HISTORIC AND DESIGN REVIEW COMMISSION

February 21, 2018

HDRC CASE NO: 2017-630
ADDRESS: 429 DEVINE ST
LEGAL DESCRIPTION: NCB 2957 BLK 1 LOT 8
ZONING: R-5,HS
CITY COUNCIL DIST.: 1
DISTRICT: Lavaca Historic District
LANDMARK: House
APPLICANT: Richard & Susan Theis
OWNER: Richard & Susan Theis
TYPE OF WORK: Construction of a single family residential structure
APPLICATION RECEIVED: December 04, 2017
60-DAY REVIEW:
REQUEST:

The applicant is requesting a Certificate of Appropriateness for approval to:

DRAWING TITLE
FOUNDATION HEIGHT
DIAGRAM
SHEET 5D

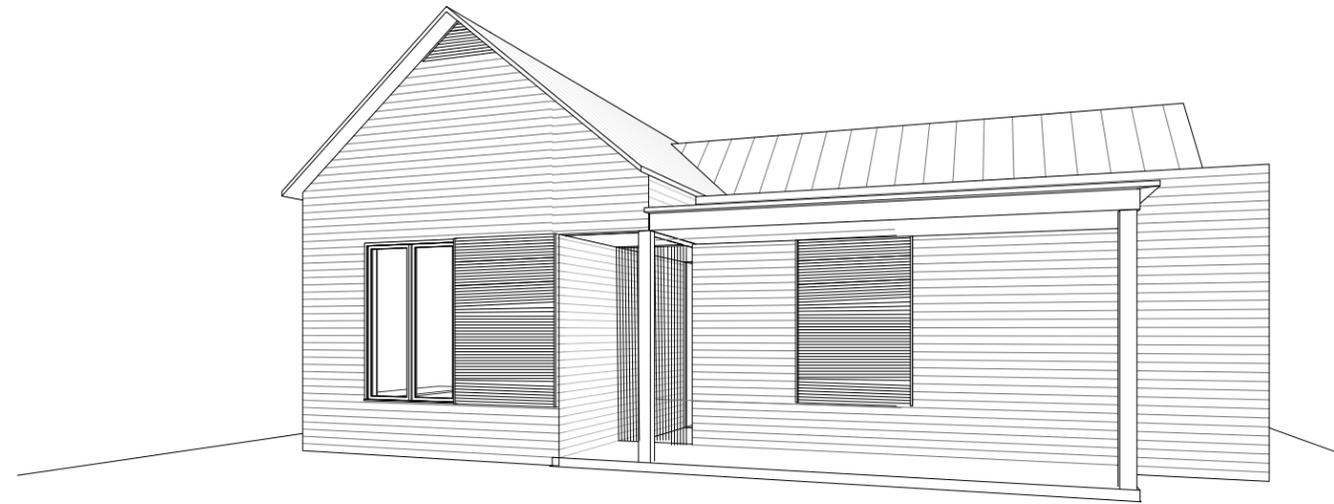
- g. FOUNDATION & FLOOR HEIGHTS – According to the Guidelines for New Construction 2.A.iii., foundation and floor height should be aligned within one (1) foot of neighboring structure’s foundation and floor heights. The applicant has noted a foundation height of four (4) inches. Foundation heights found historically throughout the district commonly feature heights of two or more feet. Staff finds that the applicant should include a foundation height comparable to those found predominantly in the district and on Devine Street.

COMMENTS/CONCERNS: ME: OVERVIEW OF PROJECT/UPDATES. ALL:
COMMENTS ADDRESSING FOUNDATION HEIGHTS - PROVIDE INFORMATION
REGARDING NEIGHBORING FOUNDATION HEIGHTS. COMMENTS
REGARDING WINDOW PROPERTIES/PROPORTIONS. CF: CONCERNS
REGARDING LENGTH OF OVERALL LEFT ELEVATION - VOID OF
BREAKS W/ EXCEPTION OF WINDOW ELEVATIONS. JG/CF: CONCERNS
REGARDING PROPOSED PARKING LOCATION - FRONT YARD PARKING
IS ~~W/~~ INCONSISTENT W/ GUIDELINES/DISTRICT... PARKING SHOULD
NOT BE LOCATED AT THE PROPOSED LOCATION.

- i. That the applicant should include a foundation height comparable to those found predominantly in the district and on Devine Street as noted in finding g.

SITE PLAN

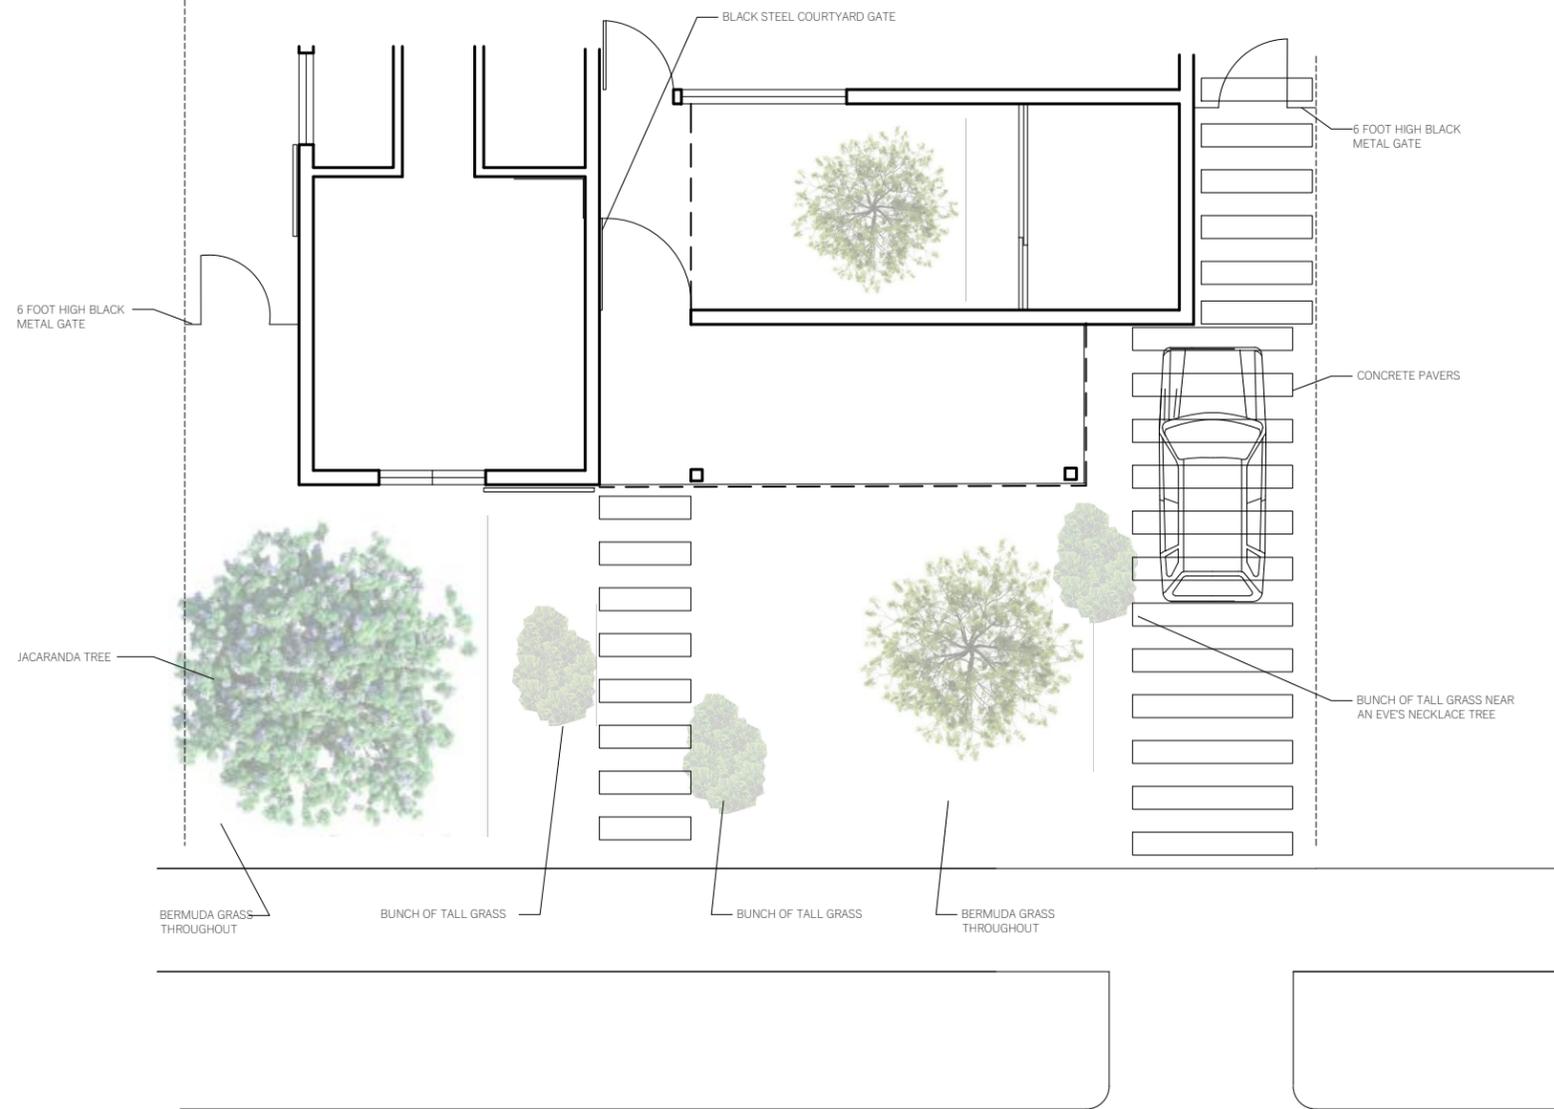
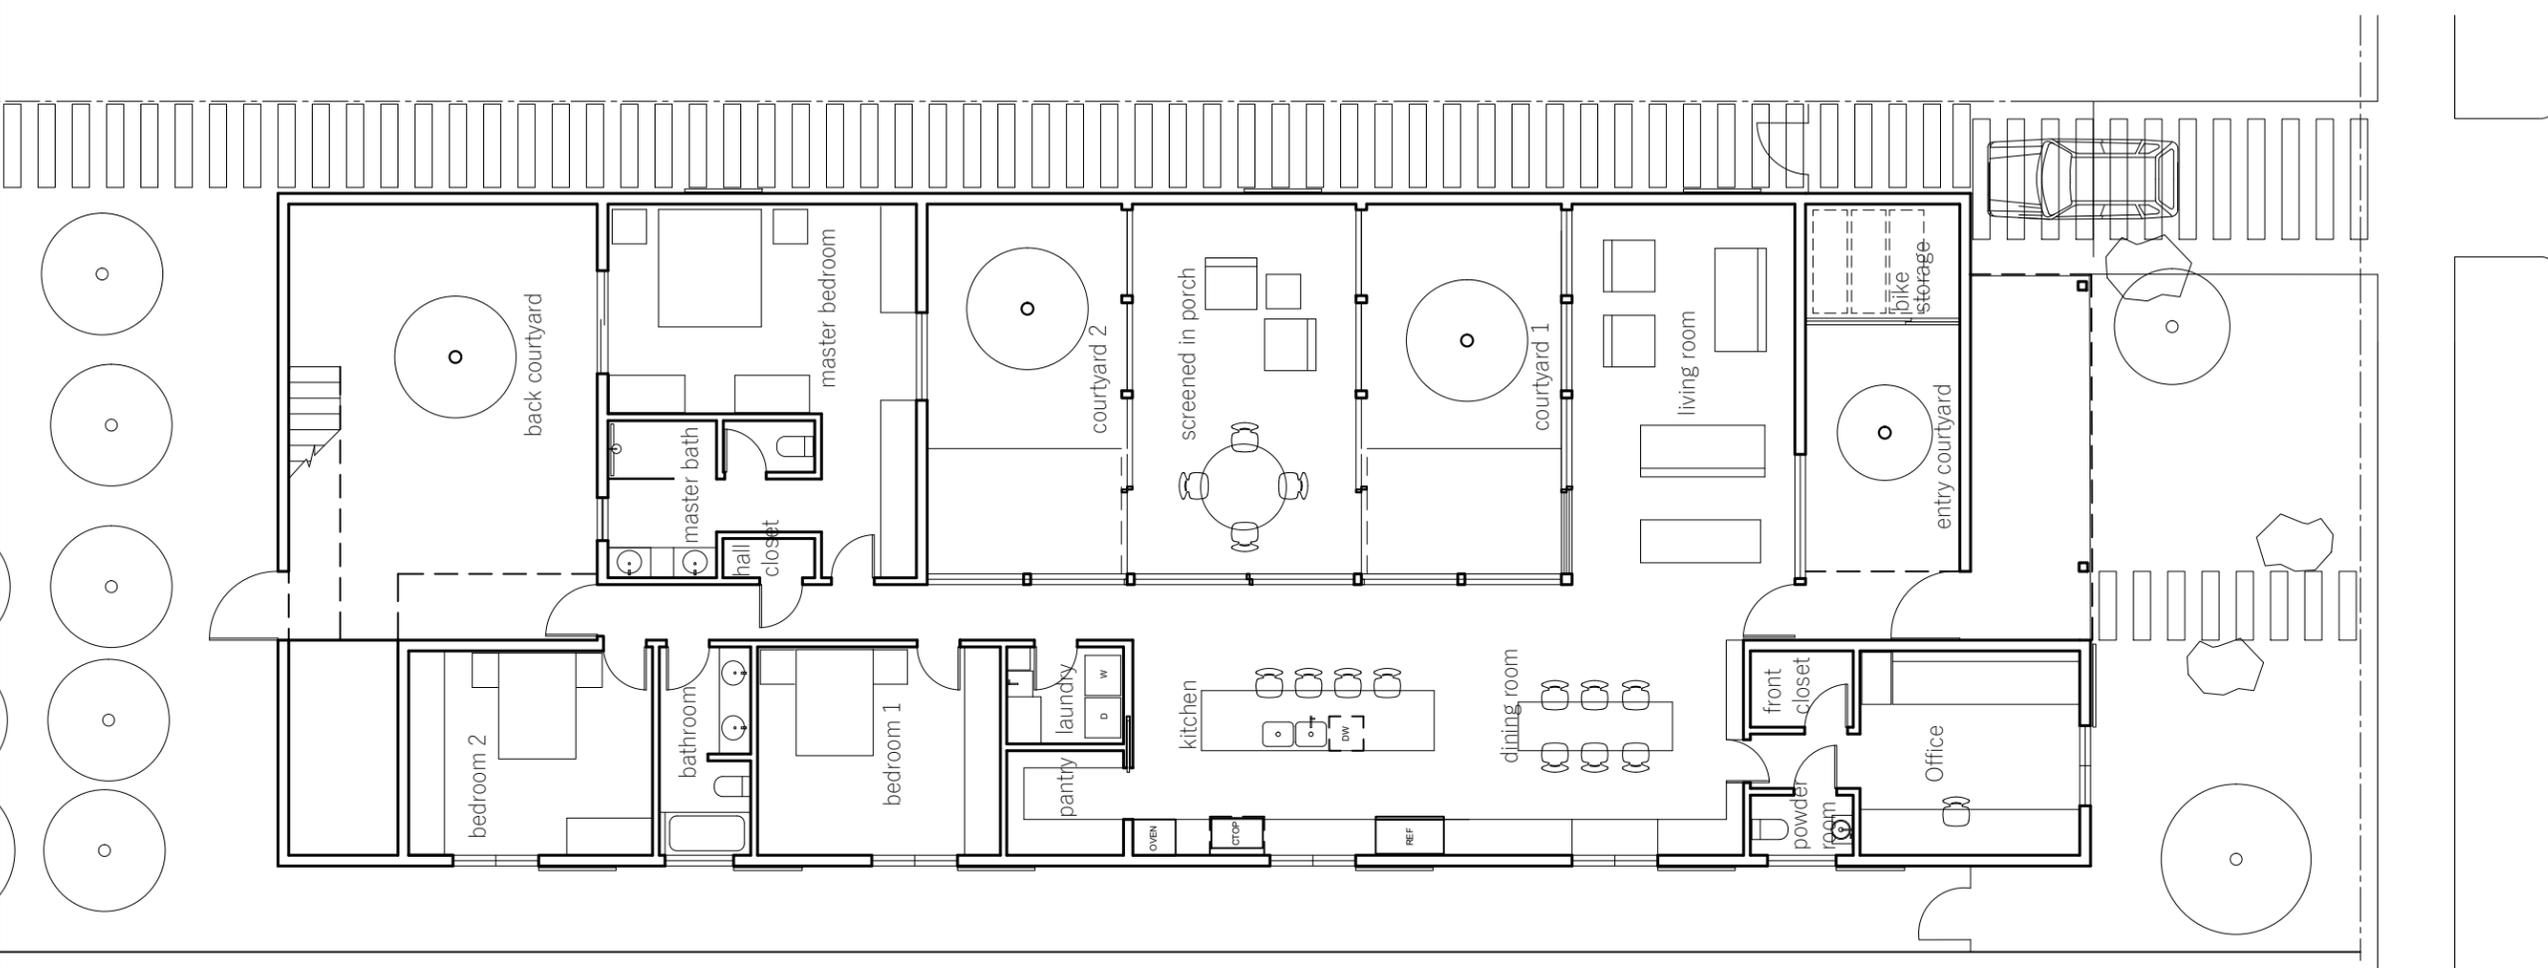
- o. **DRIVEWAY** – The applicant has proposed a single vehicle parking location utilizing the existing curb cut and a proposed shallow driveway. Per the Guidelines for Site Elements 7.A.ii., off street parking areas should not be added within the front yard setback as to not disrupt the continuity of the streetscape. Staff finds the installation of a driveway to be appropriate; however, the driveway should follow the historic example found on the block and extend along the side of the proposed new construction rather than stop at the front of the proposed new construction. The applicant has proposed driveway materials to incorporate the driveway into the proposed landscaping and to reduce the visual impact of its location.

JL: FRONT YARD PARKING IS NOT APPROPRIATE.

- ix. That the proposed front yard driveway/parking location extend along the side of the proposed new construction rather than stop in the front yard.

2 WEST ELEVATION
SCALE 1/8" = 1'-0"

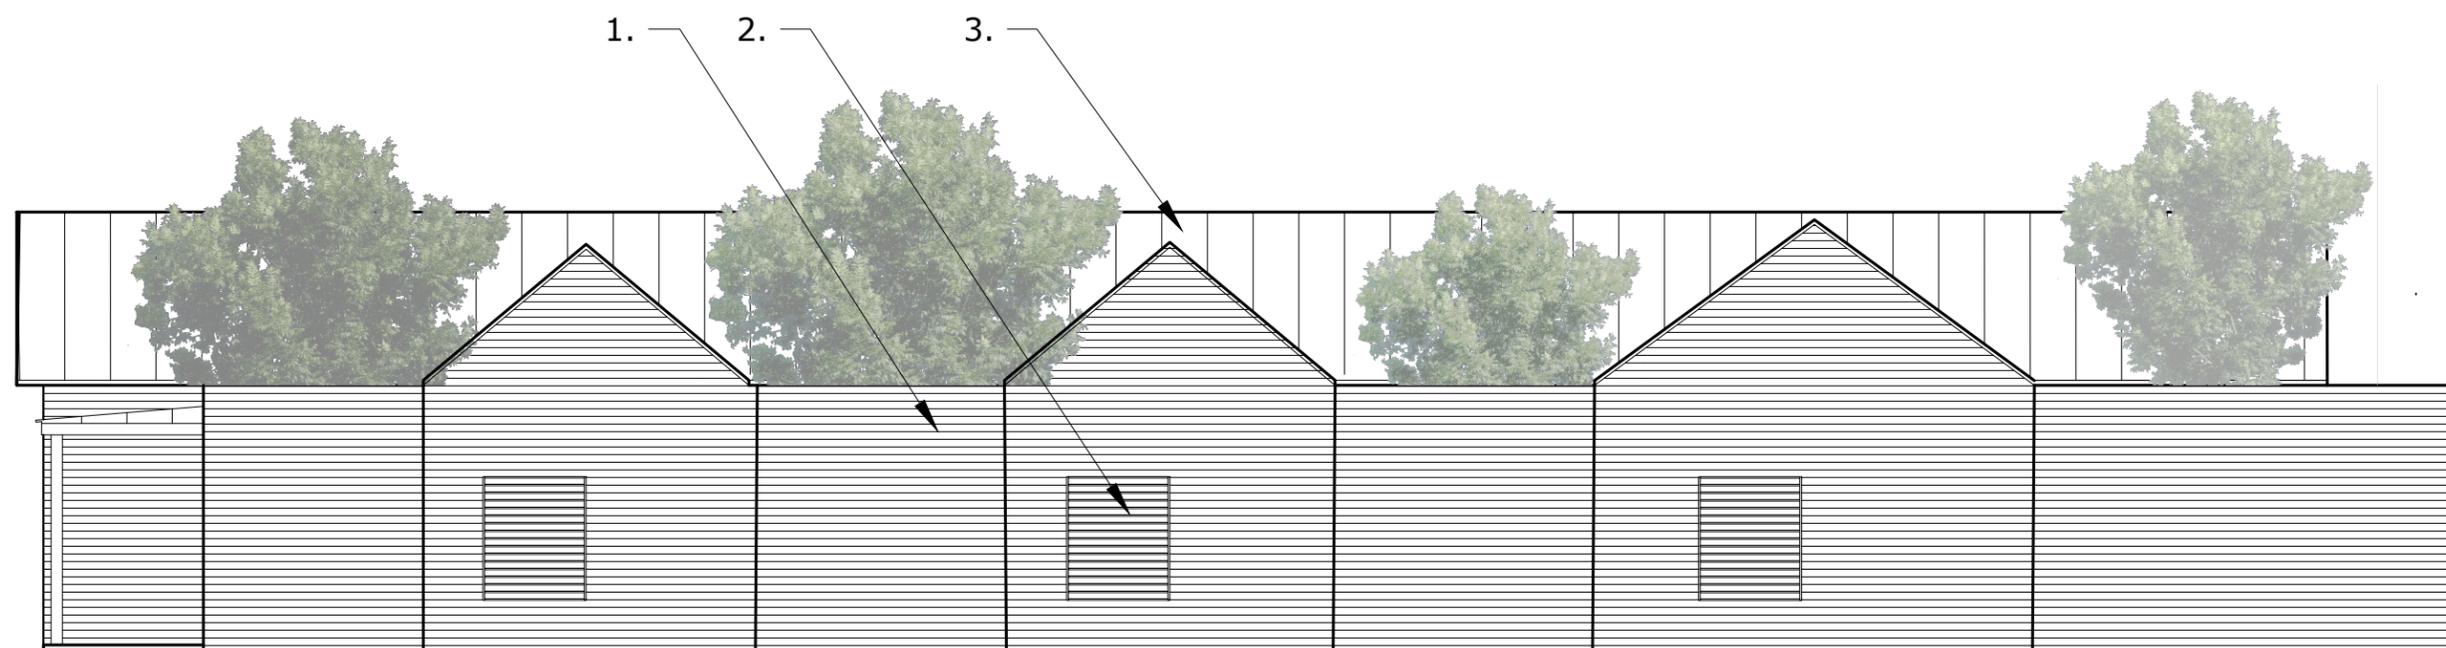
- vi. That the window specifications noted in finding l be adhered to.
- vii. That the applicant incorporate façade breaks or separation on the west façade, which currently features one continuous wall plane with only fenestration.

JG: QUESTIONS REGARDING THE WEST ELEVATION. ME- OPENINGS FEATURE SLIDING OPERABLE ELEMENTS.

JG: CONCERNS REGARDING LACK OF WINDOW FENESTRATION - PROFILE OF WINDOWS SHOULD BE PRESENT.

1 Window Detail
SCALE 1/2" = 1'-0"

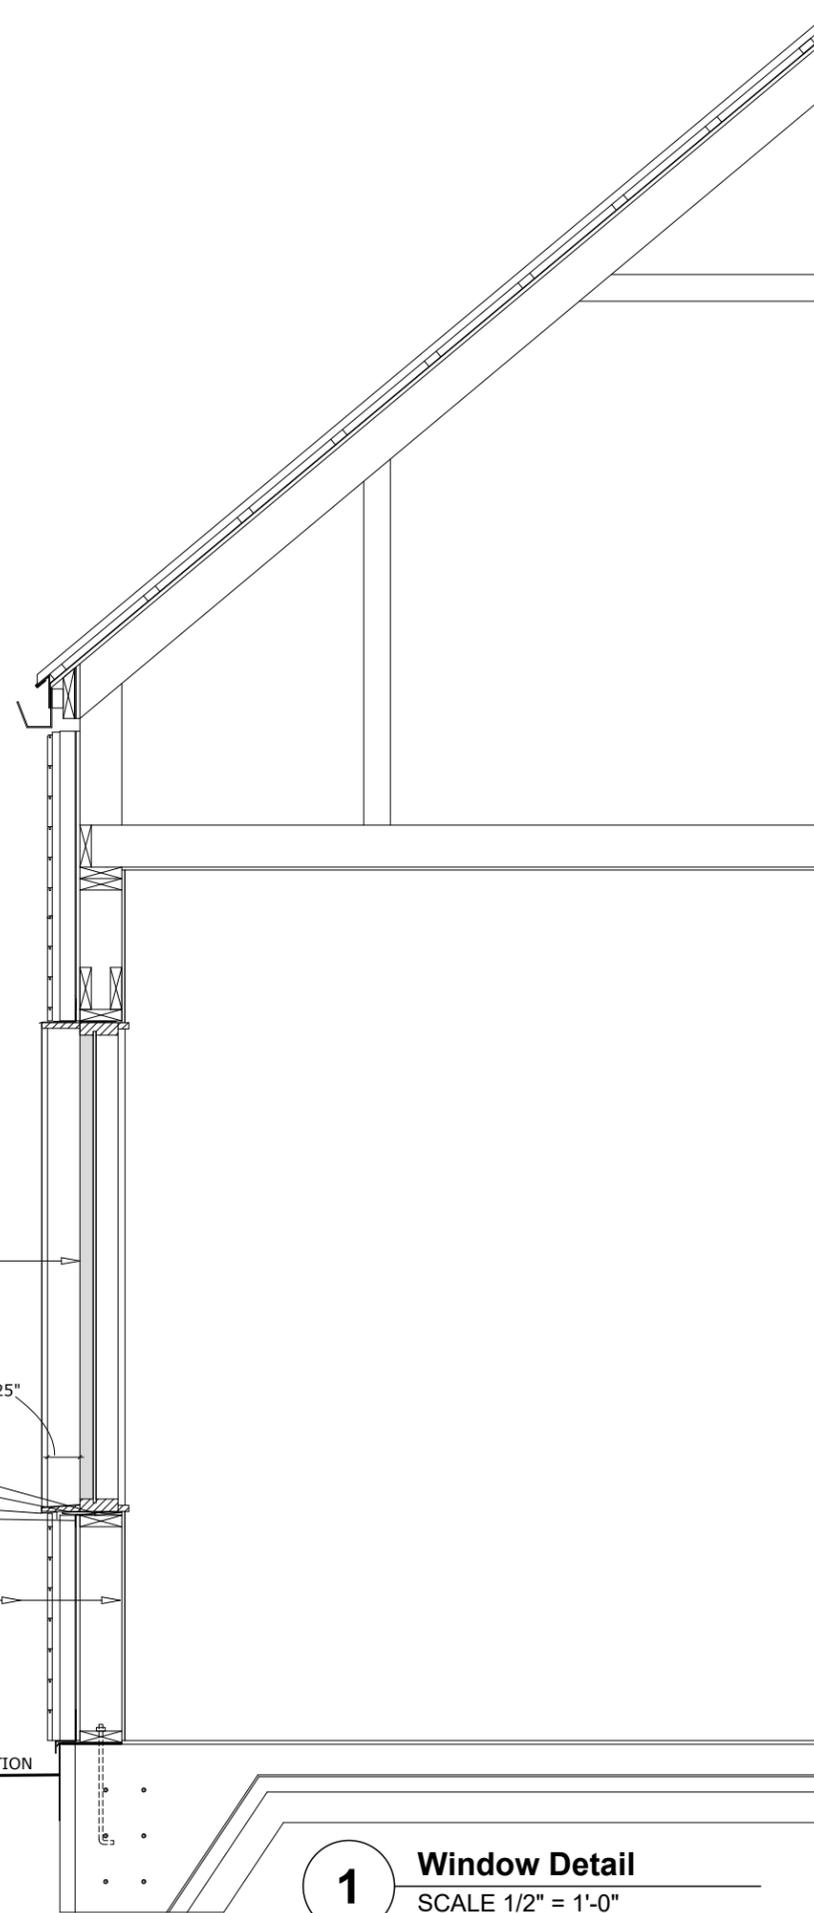
- l. MATERIALS – Regarding windows, the applicant has proposed aluminum windows. Generally, staff finds the proposed aluminum windows to be appropriate given the contemporary architectural detailing of the proposed new construction. White manufacturer’s color is not allowed, and color selection must be presented to staff. There

should be a minimum of two inches in depth between the front face of the window trim and the front face of the top window sash. This must be accomplished by recessing the window sufficiently within the opening or with the installation of additional window trim to add thickness. Window trim must feature traditional dimensions and an architecturally appropriate sill detail. Window track components must be painted to match the window trim or concealed by a wood window screen set within the opening. Details on each should be submitted to staff for review.
